Subdivision and Land Development Cover  
Page for SLD # 07-25

Project Name: Quaker Park Redevelopment

Status: UNDER REVIEW

**RE: Sketch Plan Review**  
**1001 E. Hector Street**  
**Whitemarsh Township, Montgomery County, PA**  
**S/LD # 07-25**  
**Our Project Number 2025-01046**

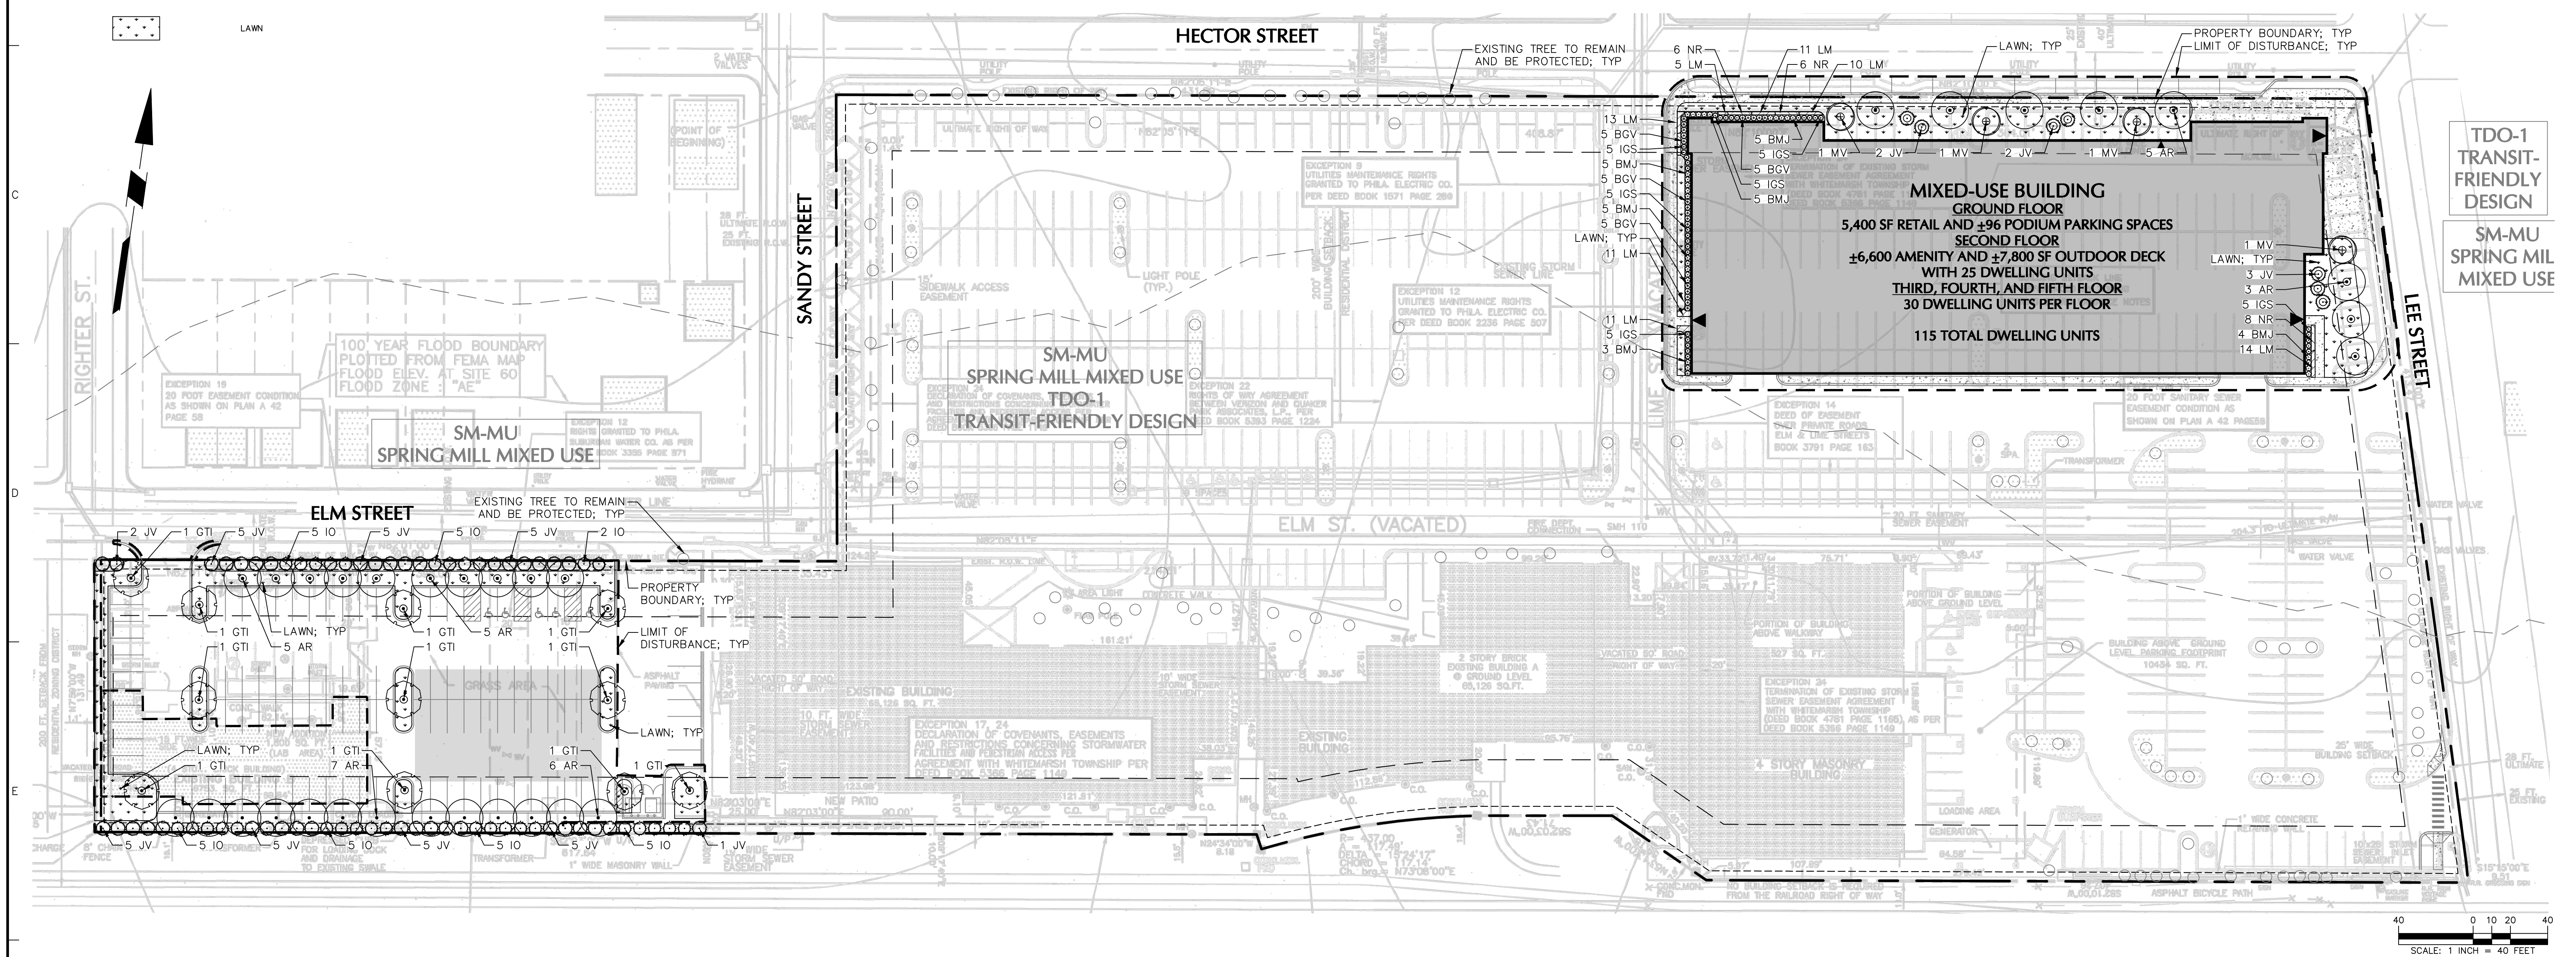
**A landscape plan is noted. However, a table showing the replacement formulas, how many inches are being replaced based on Chapter 55, and a detail shall be provided. In addition, the landscape plan denotes monoculture. This should be reduced dramatically.**
